**US Army Corps
of Engineers**
Walla Walla District

Lower Granite Sedimentation Study

Preliminary Evaluation and Progress Report

CENPD-PE-PF (CENPD-PE-TE/9 Aug 93) (1105) 2nd End
Mr. Weaver/kb/(503)326-3826
SUBJECT: Lower Granite Reservoir Dam - Induced Flooding at
Lewiston, Idaho

FIGURE 4

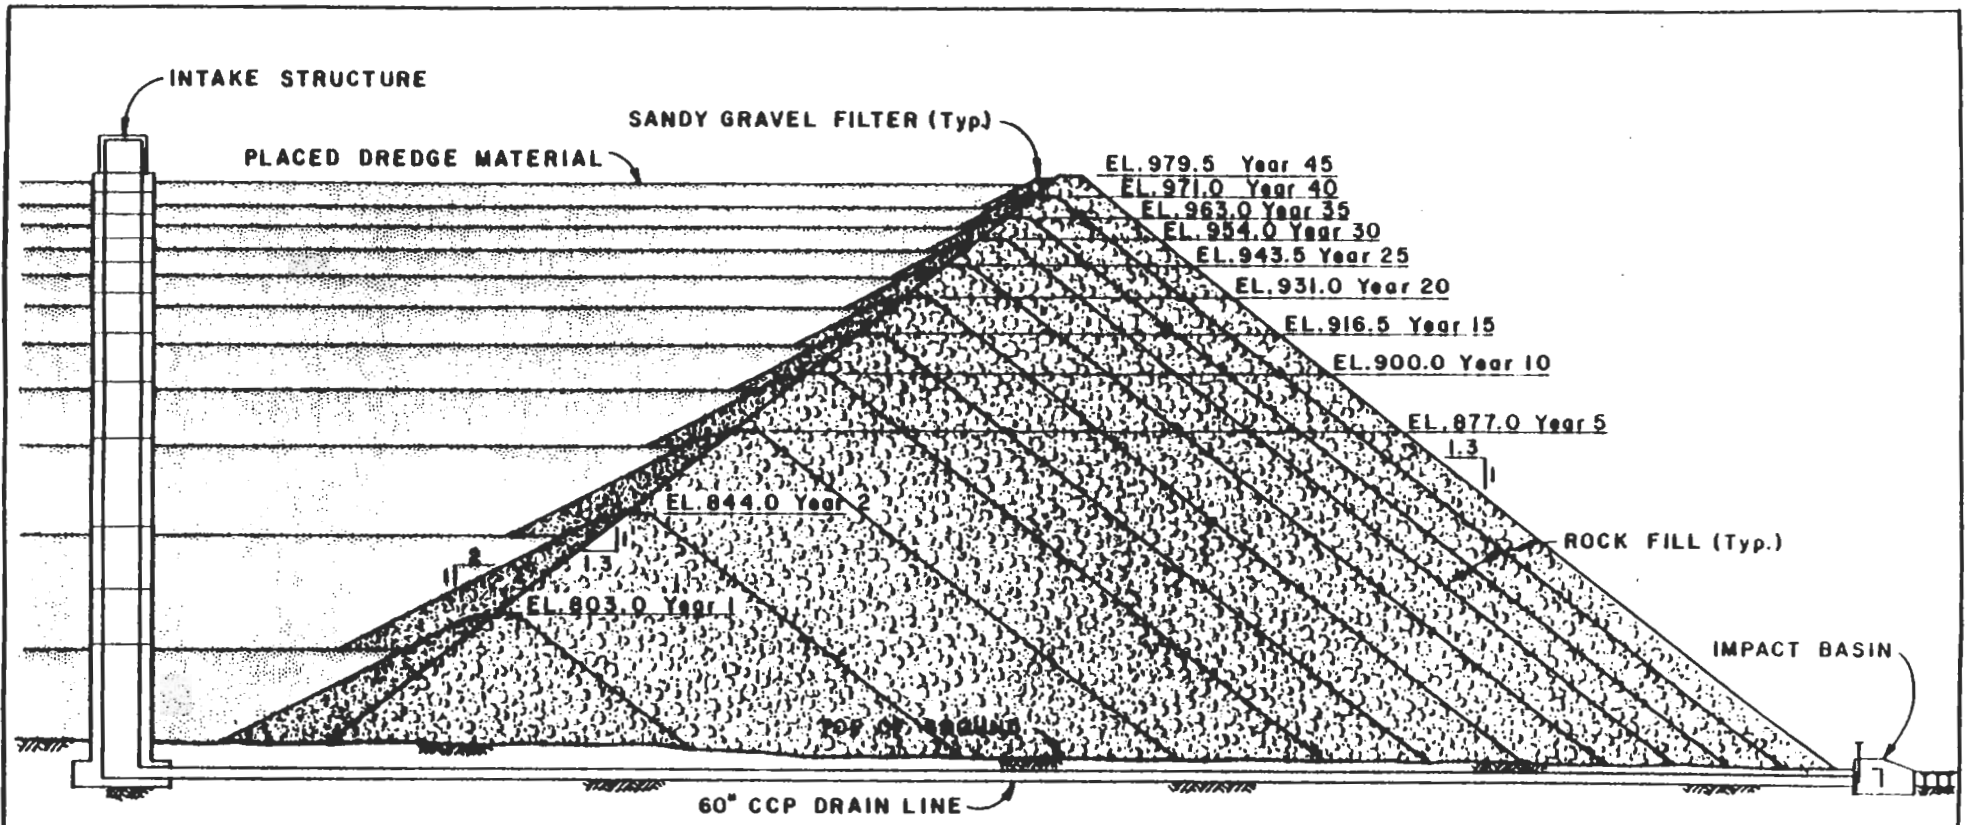
The dredging disposal plan calls for a containment dike which will eventually reach a height of 245 feet at Dry Creek, and even higher dikes at other sites. There appears to be an additional lift requirement of 35 to 104 feet from the reservoir pool elevation of 736 feet NGVD for the alternatives identified in Appendix E. The pumping distance from shore is not identified, but appears to be around 3,000 feet. It is unlikely that a hopper dredge, even with a booster pump(s), will be able to pump into the disposal site at these heights and that distance. Adding more boosters would increase the pumping capability, but at significantly increased cost and reduced efficiency. At some point, it would likely be necessary to stockpile the material, and/or transfer it to be hauled up into the land disposal site. Consequently, dredging and disposal costs would likely increase significantly in the future if this alternative is used. In addition, the cost estimate does not appear to reflect real estate requirements, including acquisition costs, nor does the report indicate who would be responsible for providing the disposal sites.
